RENESAS TECHNICAL UPDATE

Product Category	MPU/MCU	Document No.	TN-RX*-A0228A/E	Rev.	1.00
Title	Errata to User's Manual: Hardware Regarding the I ² C-bus Interface (RIIC)		Information Category	Technical Notification	
Applicable Product	RX64M Group	Lot No.	Reference Document	RX64M Group User's Manual: Hardware Rev.1.10 (R01UH0377EJ0110)	
		All

This document describes corrections to the "I²C-bus Interface (RIIC)" chapter in RX64M Group User's Manual: Hardware.

Figure 42.28 Set/Clear Timing of the AASy and DID Flags during Reception of Device-ID Address

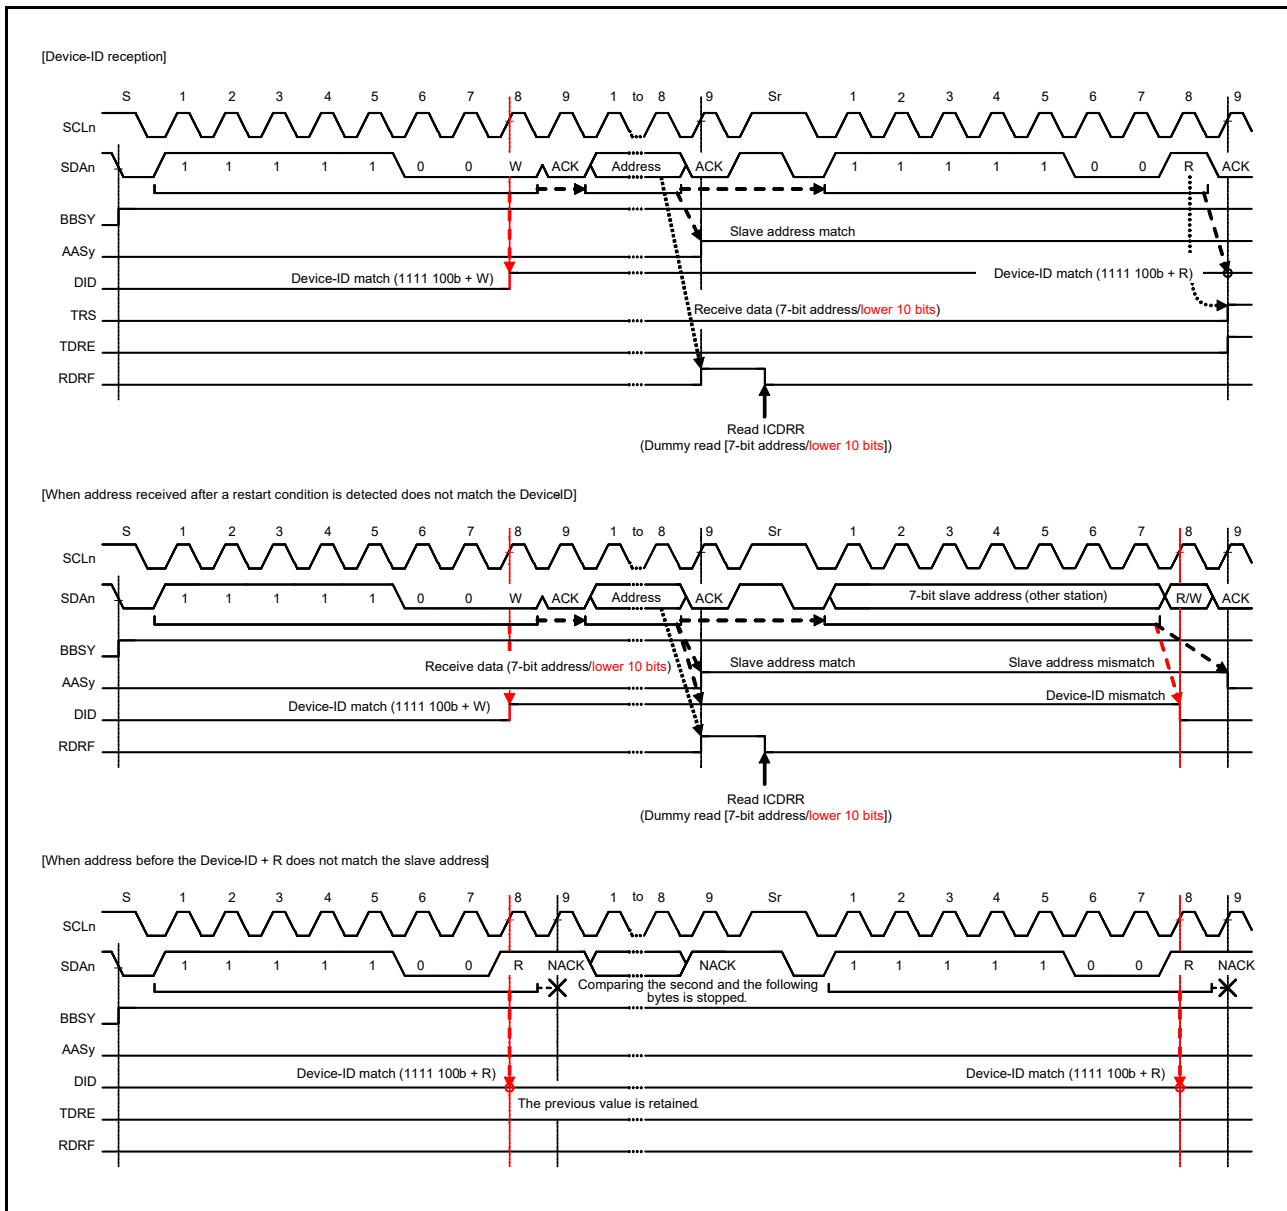
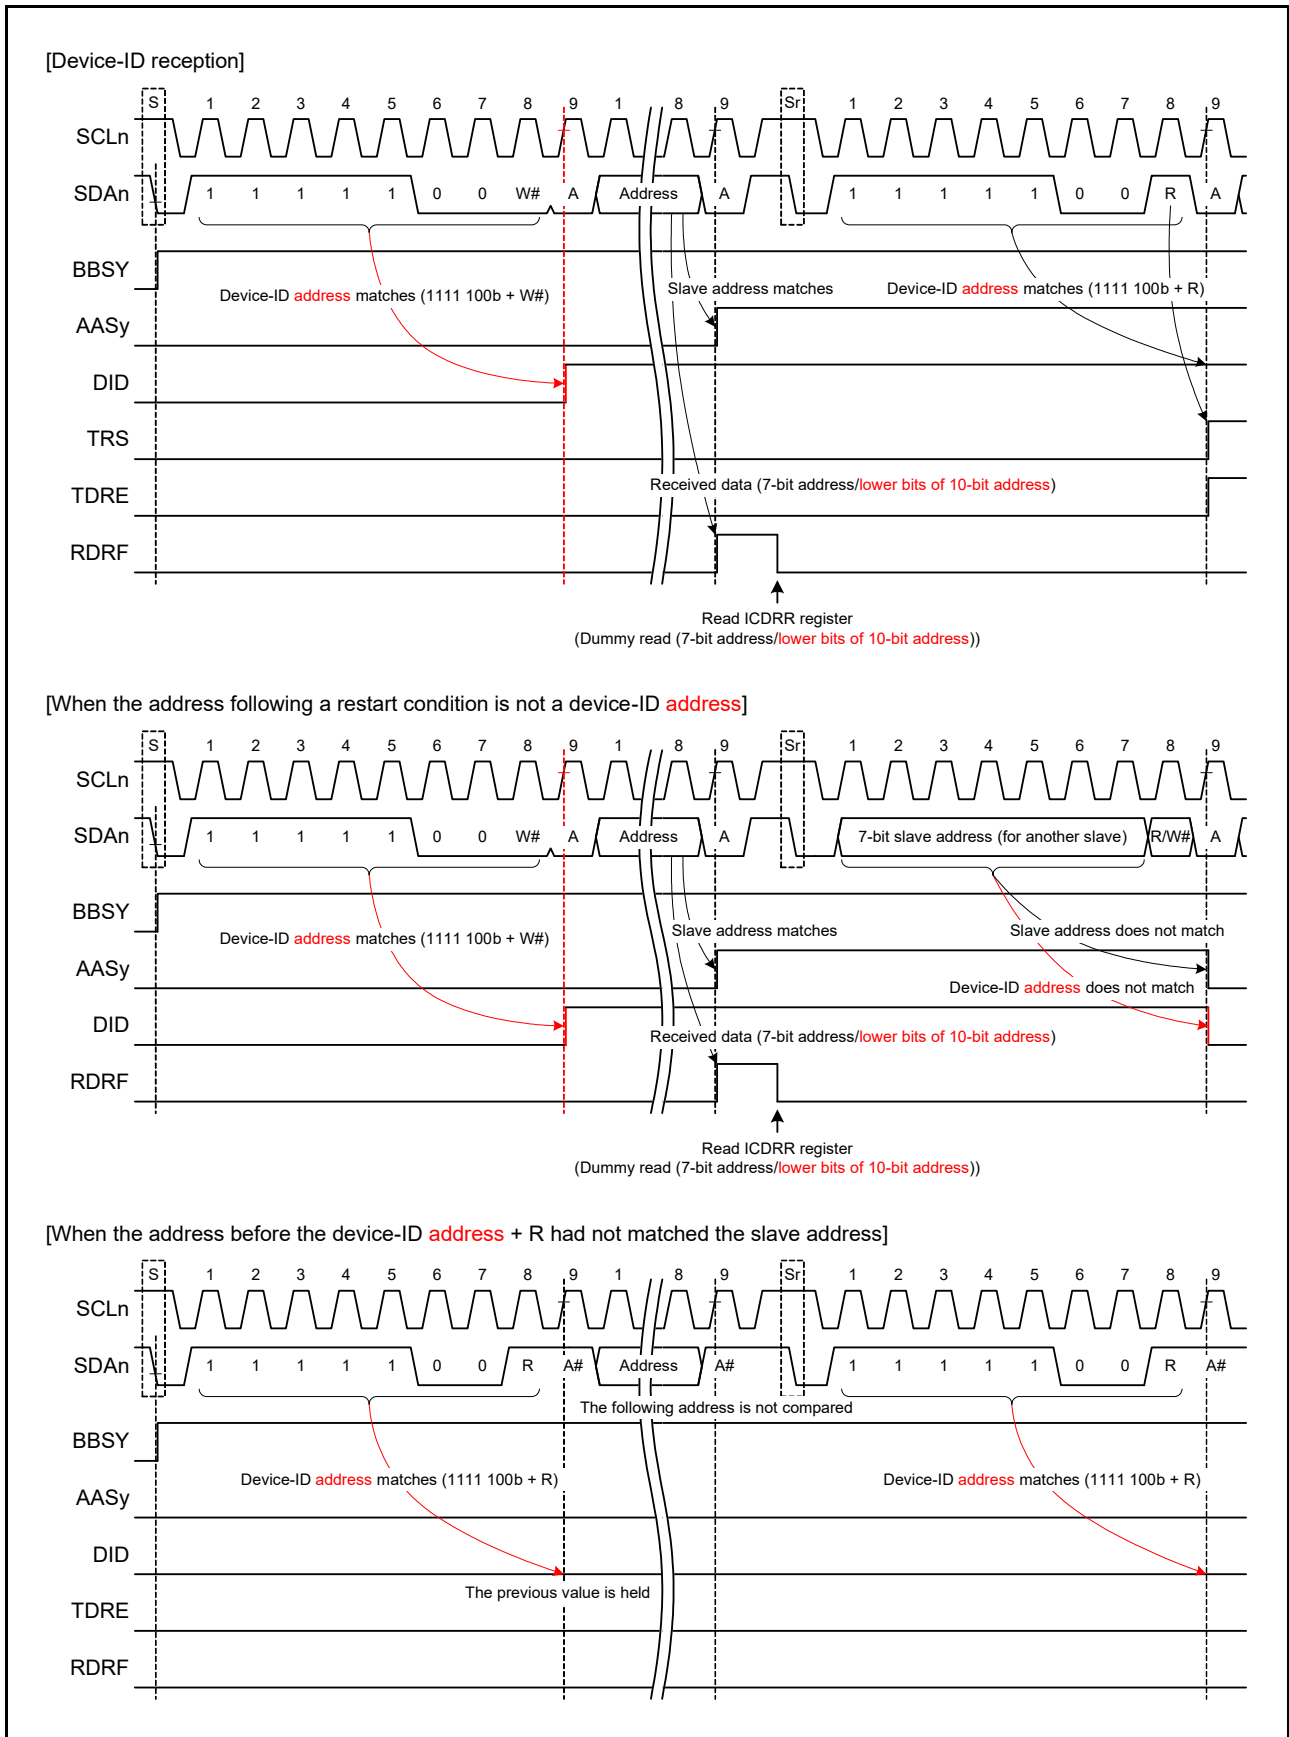
Figure 42.28 in section 42.7.3, Device-ID Address Detection is corrected as follows.

Figure 42.31 Suspension of Data Transmission When NACK is Received (NACK = 1)

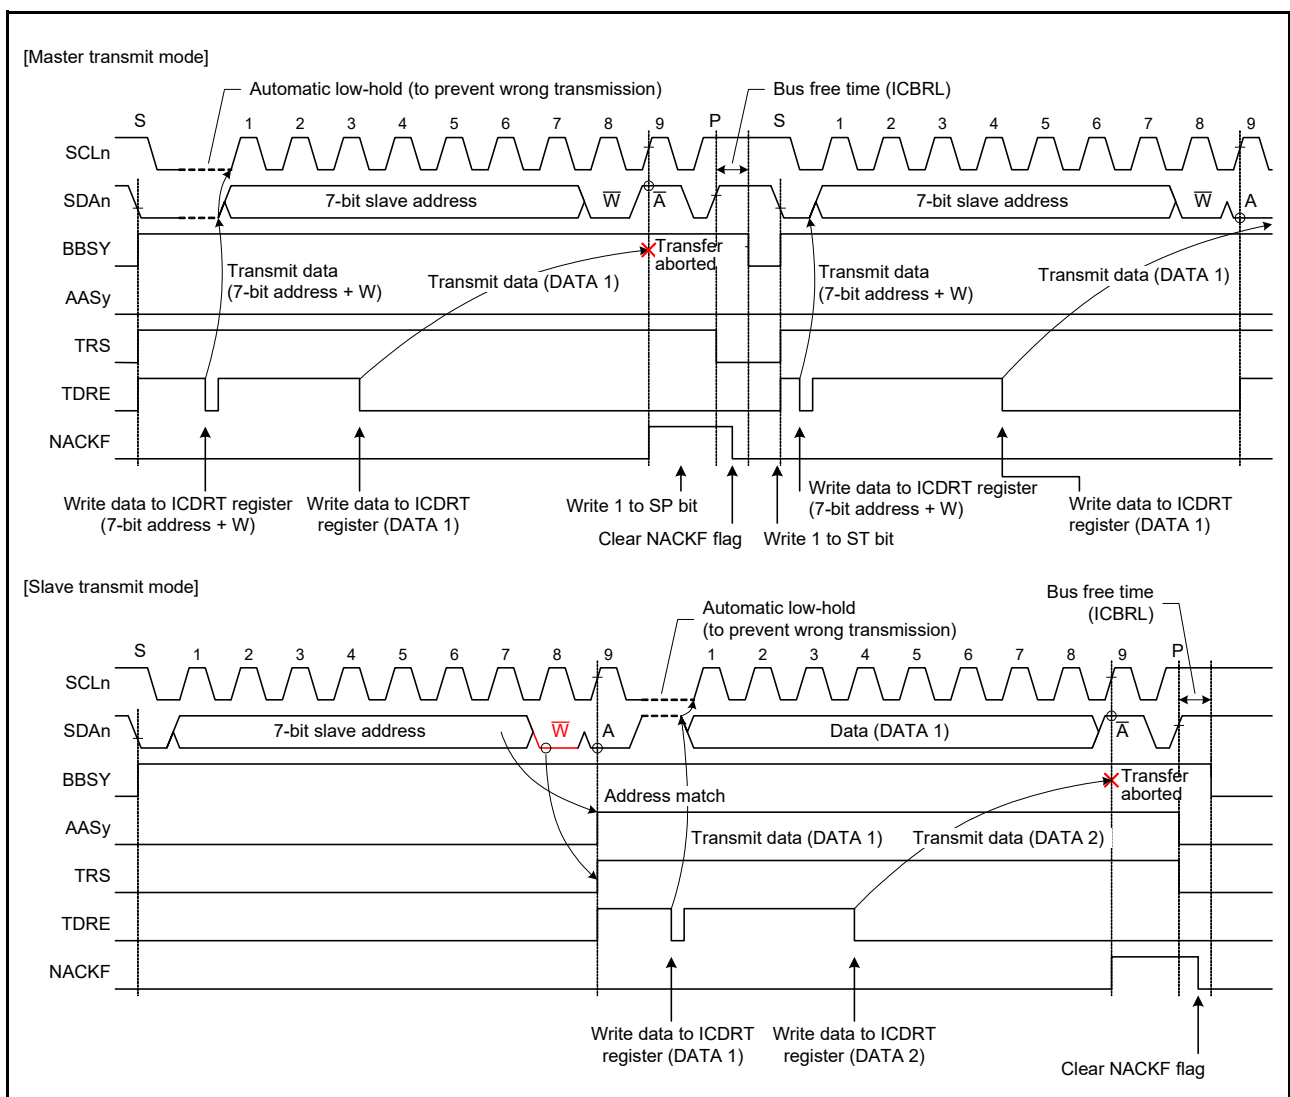
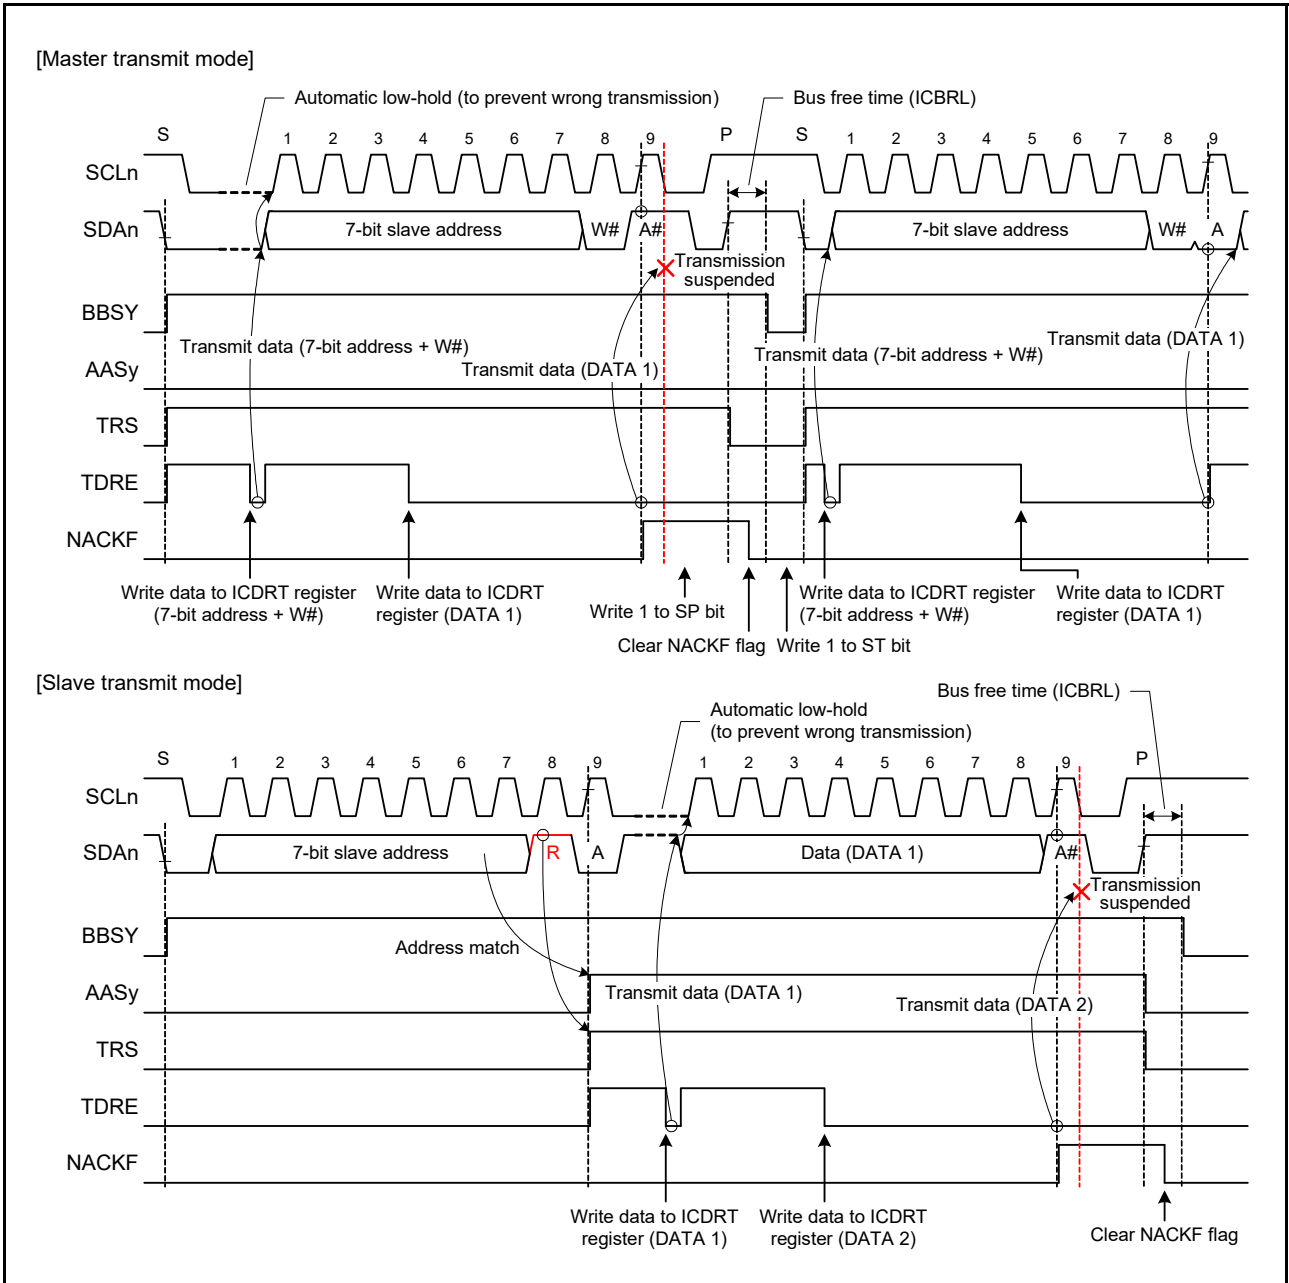
Figure 42.31 in section 42.8.2, NACK Reception Transfer Suspension Function is corrected as follows.

Figure 42.40 Additional SCL Output Function (CLO Bit)

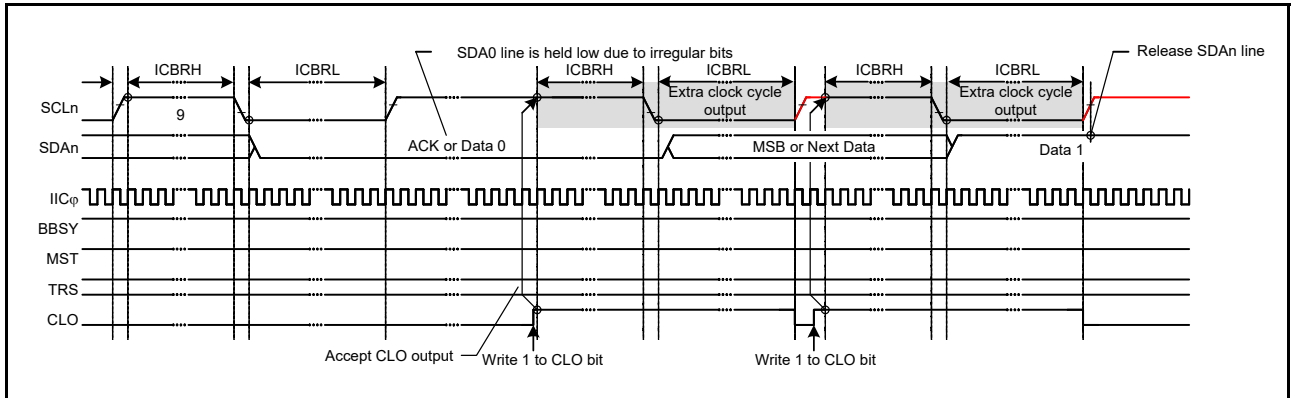
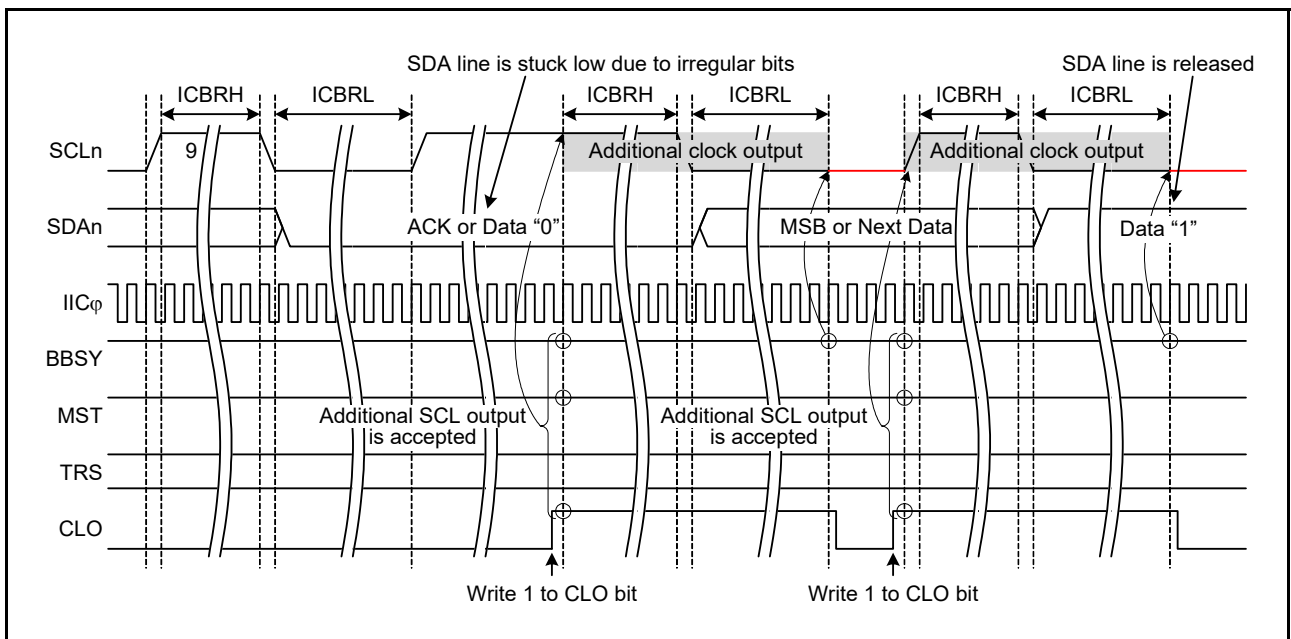
Figure 42.40 in section 42.11.2, Extra SCL Clock Cycle Output Function is corrected as follows.
